**SUBJECT:** **Customer Satisfaction Program 21B05**  
 Certain 2016-2018 Model Year Police Interceptor Utility Vehicles  
 High-Speed Cooling Fan Motor Relay

# CERTAIN 2016-2018 MODEL YEAR POLICE INTERCEPTOR UTILITY VEHICLES — HIGH SPEED COOLING FAN MOTOR RELAY

## SERVICE PROCEDURE

FIGURE 1

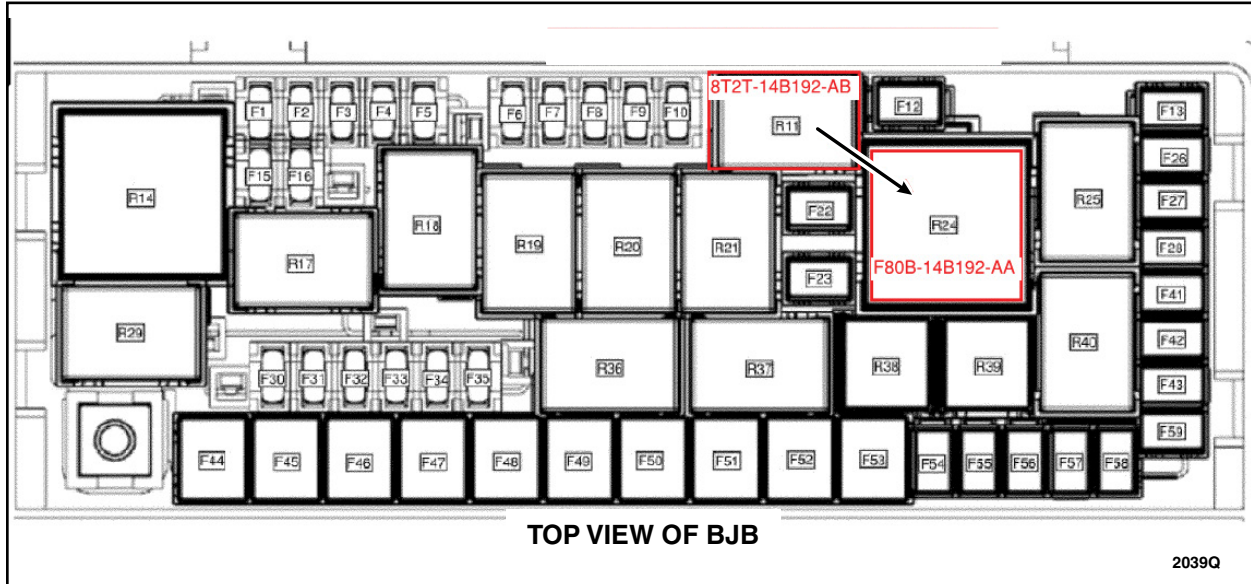
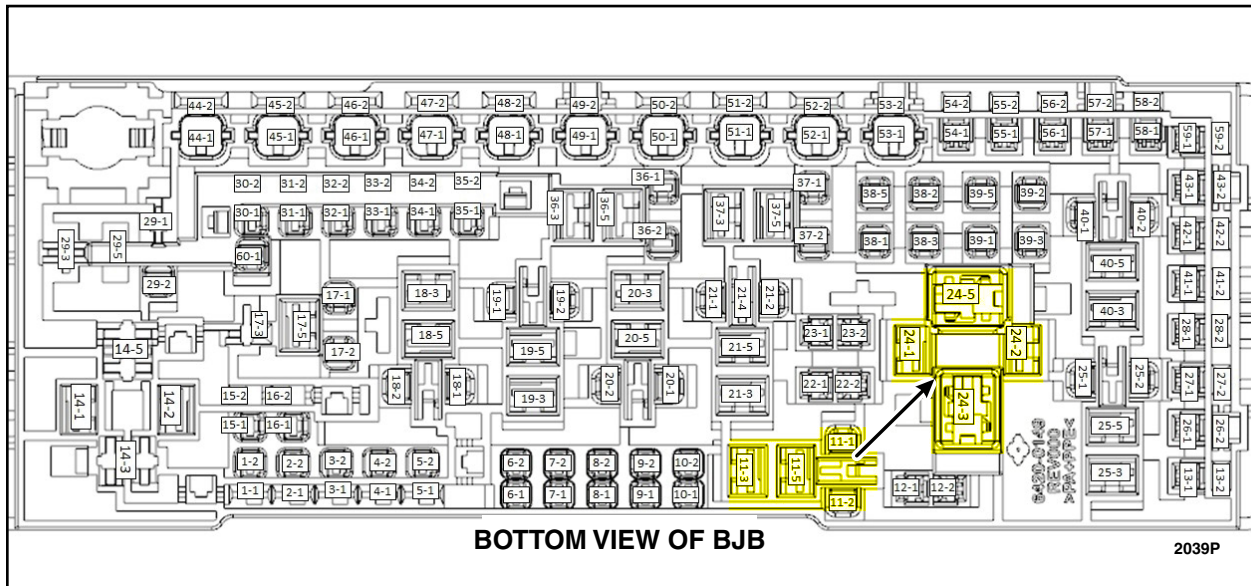
**NOTE:** The high speed cooling fan relay (R11) will be relocated to the (R24) position in the Battery Junction Box (BJB) as shown in Figures 1 and 2.

**FIGURE 14**

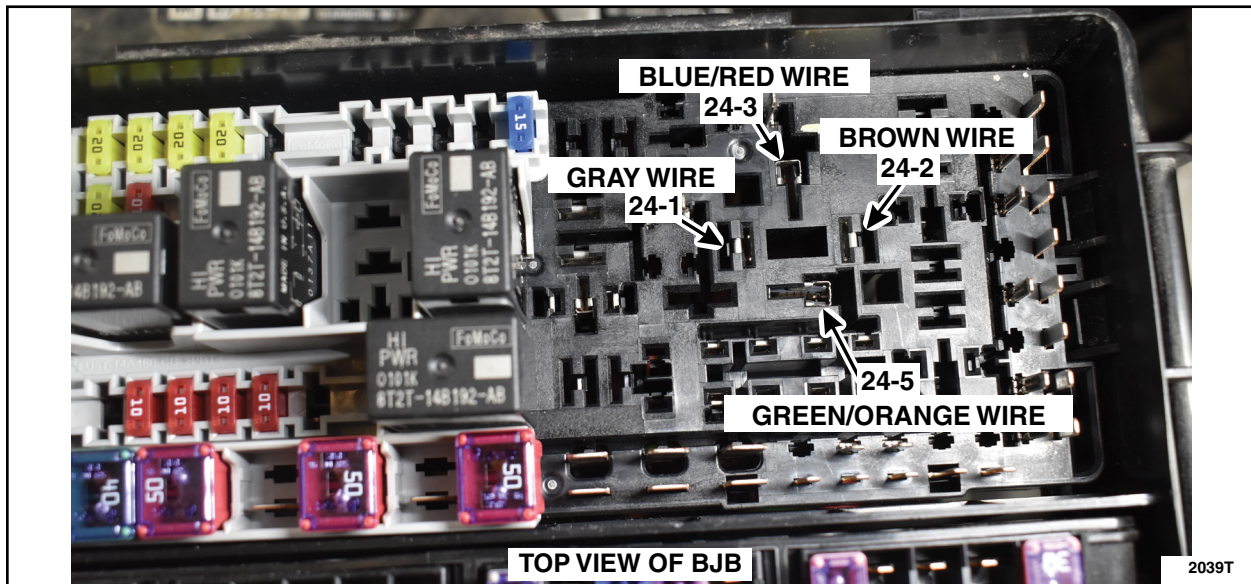
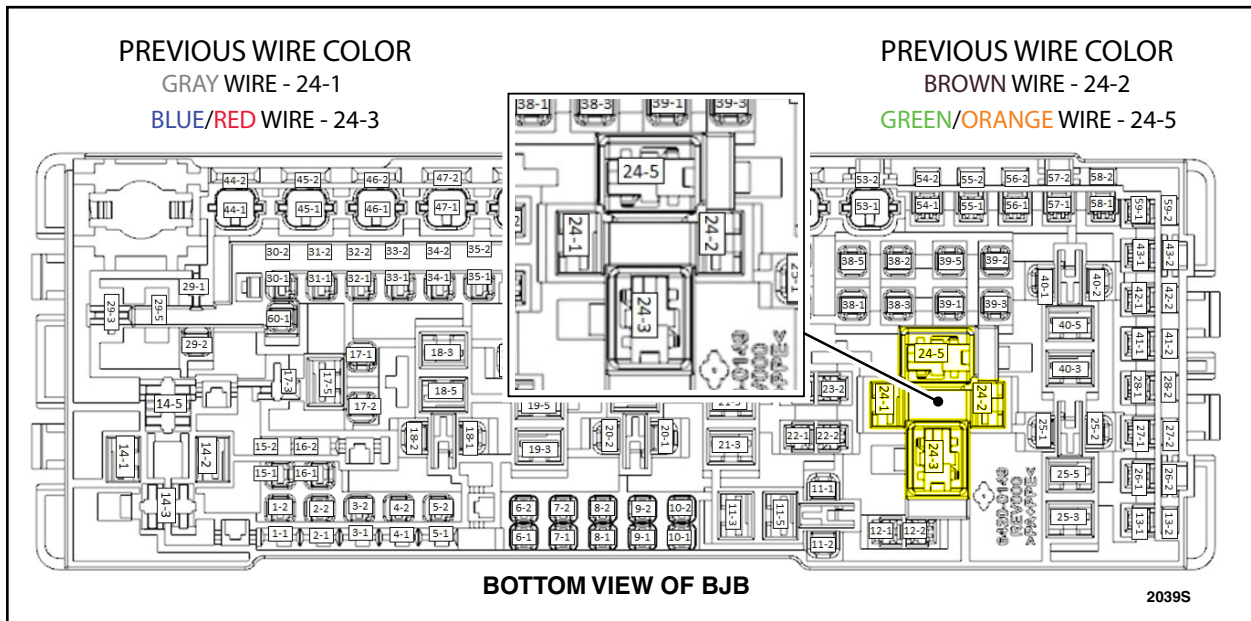
10. Install the four (4) wires, removed from the original relay with *new* terminal ends, into the *new* relay R24 cavities as noted below. See Figures 14 and 15.

- Install what was the original gray wire into cavity 24-1.
- Install what was the original brown wire into cavity 24-2.
- Install what was the original blue/red wire into cavity 24-3.
- Install what was the original green/orange wire into cavity 24-5.
